Regulation No. **Synthesis DRAFT 2010_02** **Q-Size**
UNIFORM PROVISIONS CONCERNING THE APPROVAL OF **[ISOFIX Integral/ Enhanced]**
CHILD RESTRAINT SYSTEMS USED ONBOARD OF MOTOR VEHICLES.

6.3.1.2. Mass

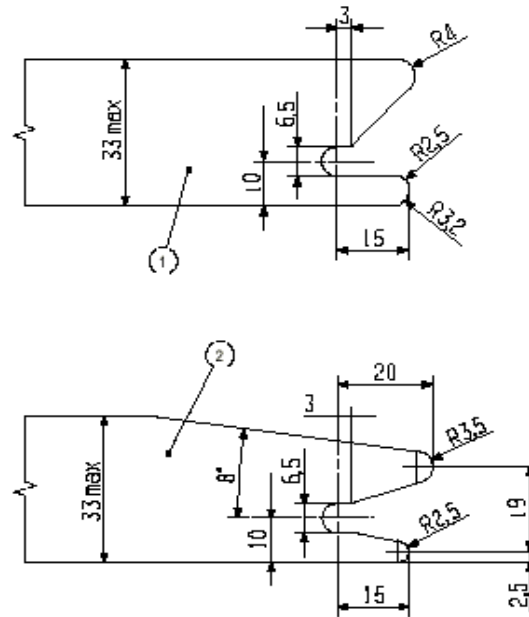
Comment [I13]: Take into account remark from CI in § 6.8.7

Figure 2
Arrangement for testing a rearward-facing device,
not supported by the dashboard

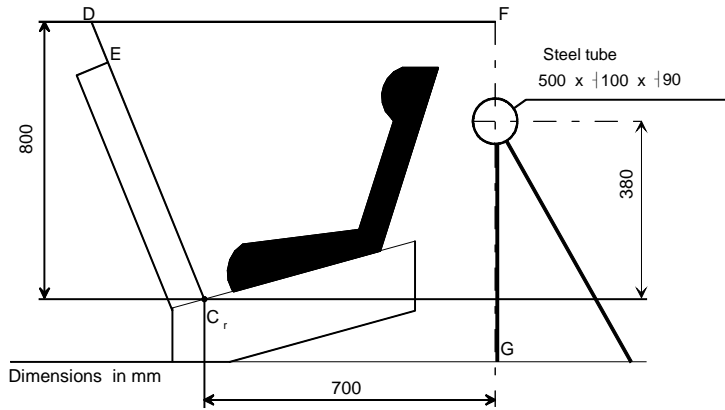
Comment [I21]: Sweden request:
We want to exclude this paragraph because there is no need for such a requirement. All traffic safety experts in Sweden have always recommended that children should use the rear-facing child restraints until the top of the child's ears reach the top of the restraint, which means that lots of children travel with the top of their head above the top of the restraint and we have never seen any serious injuries due to this. (Of course in roll over collisions with massive roof intrusion, even children have been seriously injured)

Comment [I22]: Comment from TUB - "Has the bar been removed?". Answer is "NO" due to the fact that it is not used as an anti-rotational device but as a possible contact during dynamic test.
